CHIANG RAI / MAE FAH
Luang-Chiang Rai Intl.

MARKING AIDS RWY 03/21 AND EXIT TWY

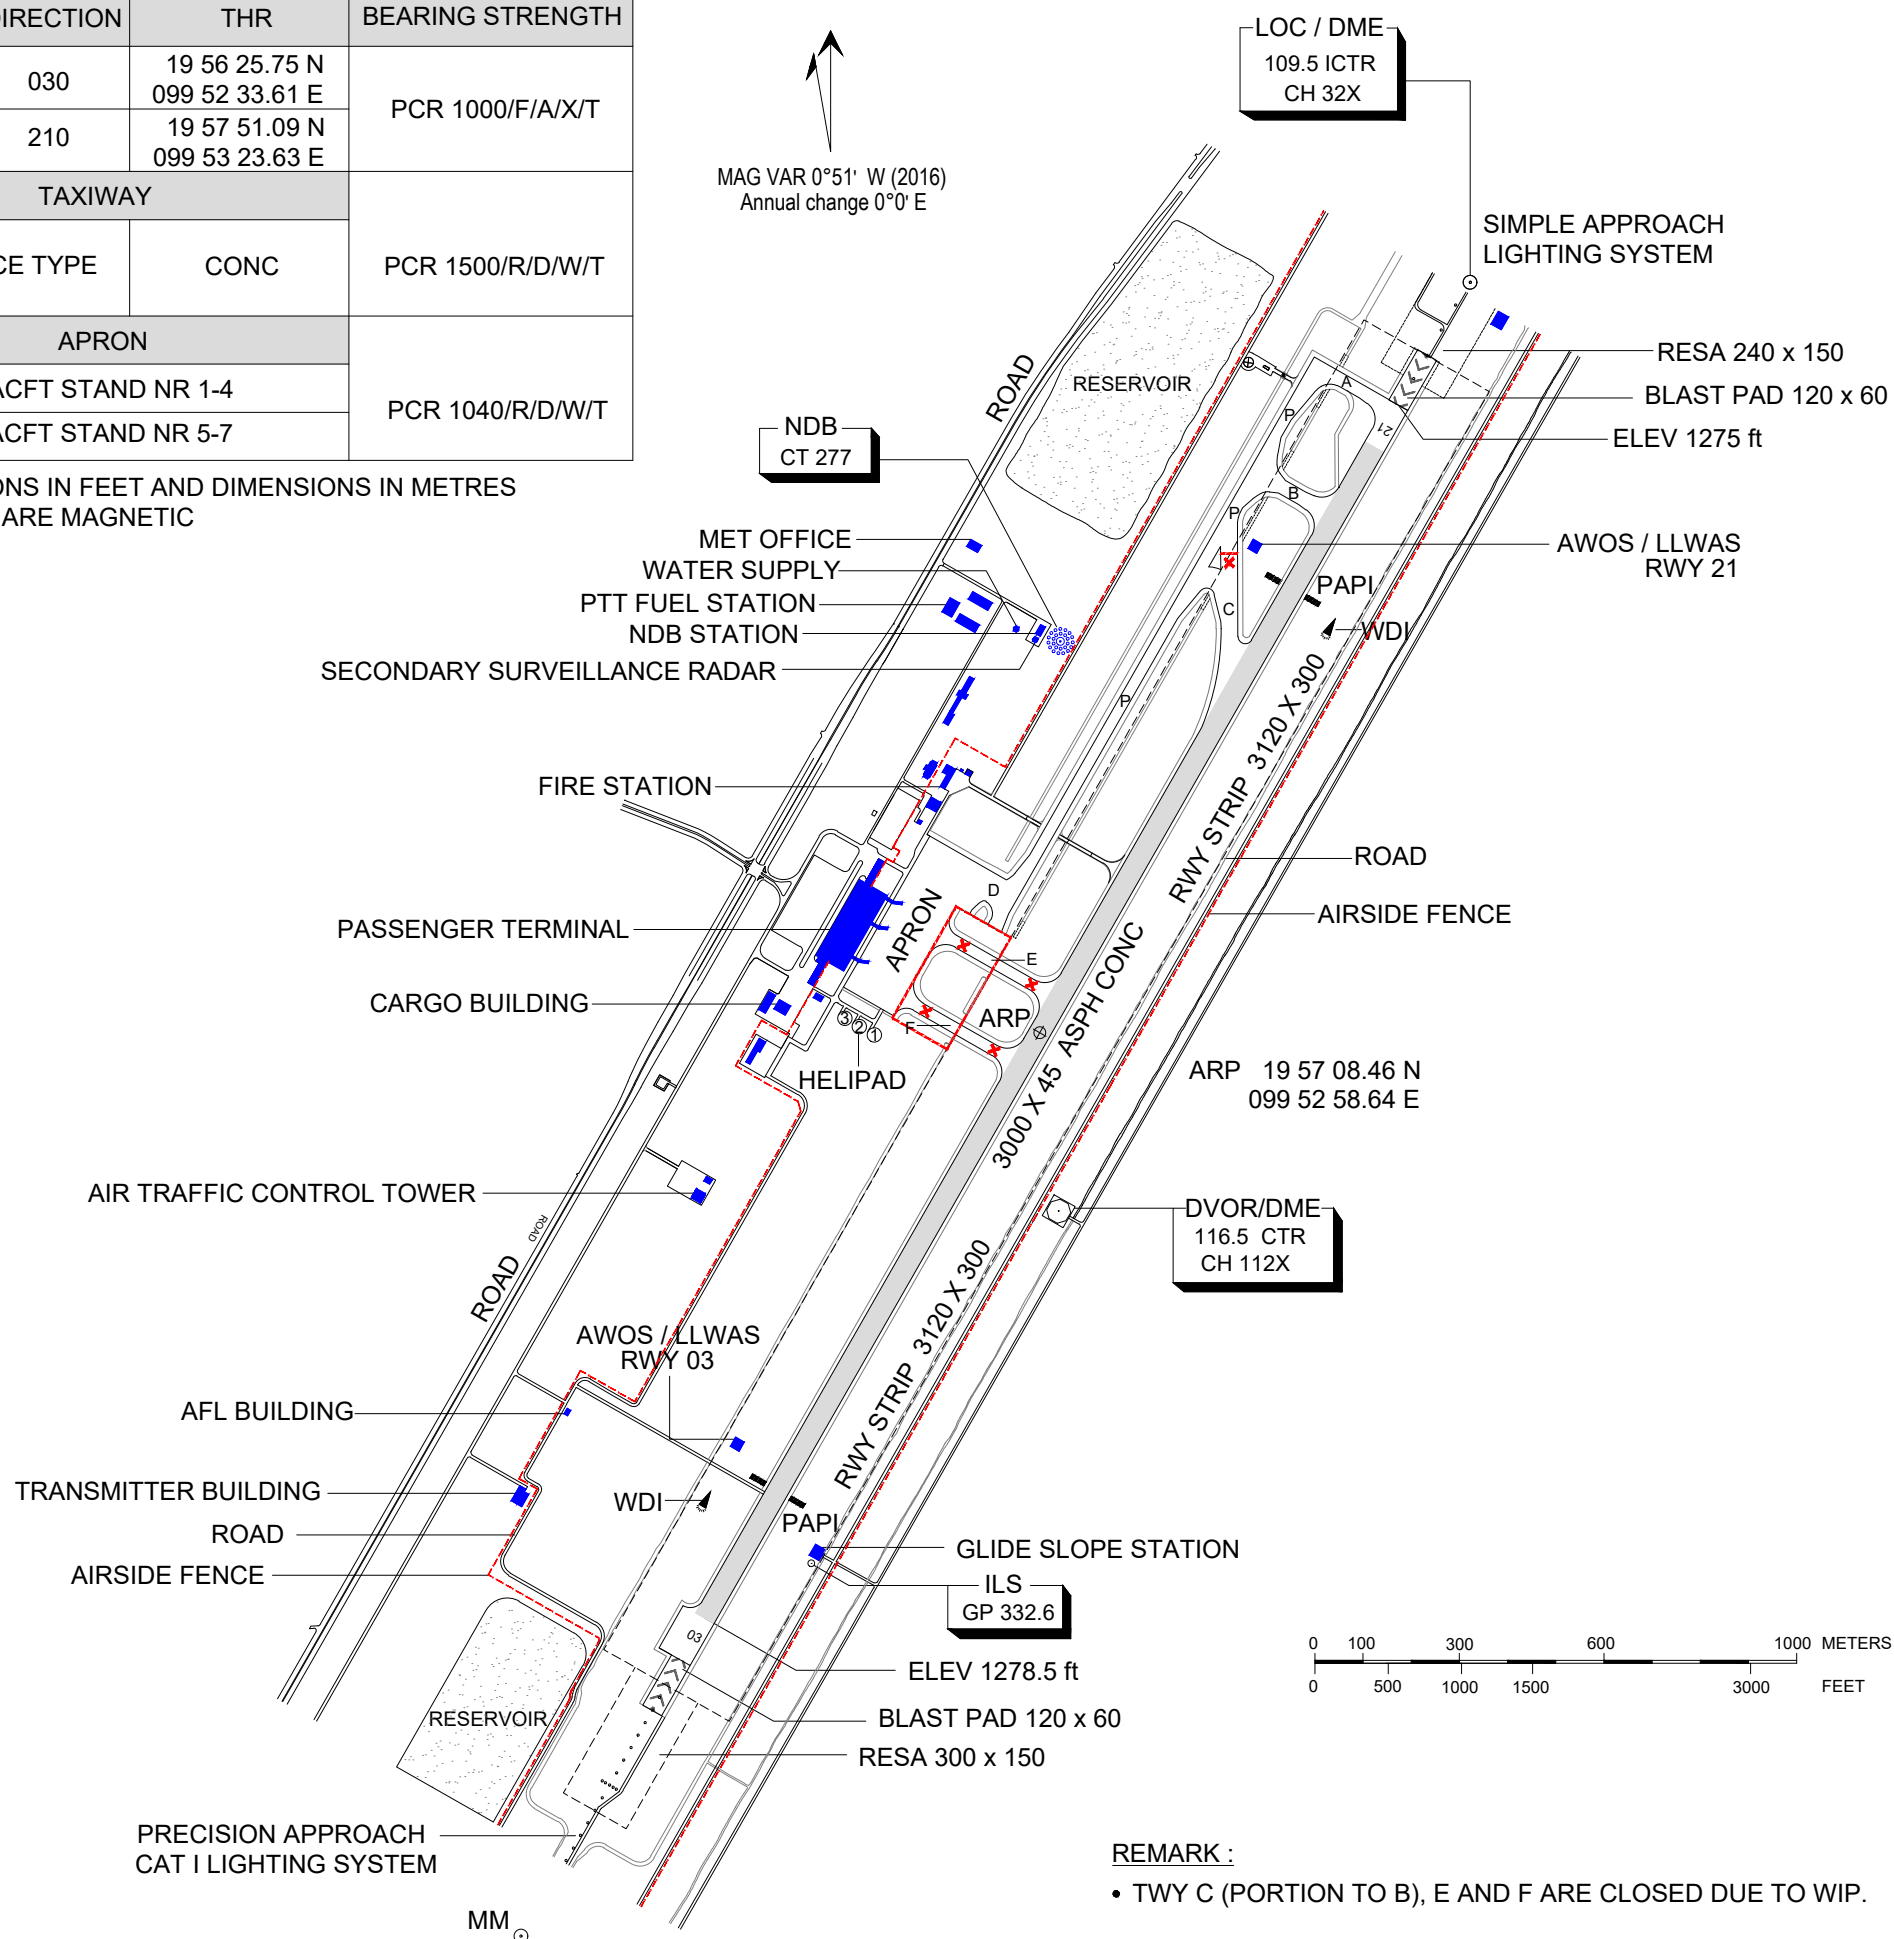
CHANGE : RESA 03 DIMENSION REVISED. SWY 03 CANCELLED. BLAST PAD 21 ADDED. NEW TWY A, TWY B, TWY C, TWY D, TWY P ADDED. FORMER TWY A REVISED NAME AS TWY F. FORMER TWY B REVISED NAME AS TWY E. PCN CHANGED TO PCR
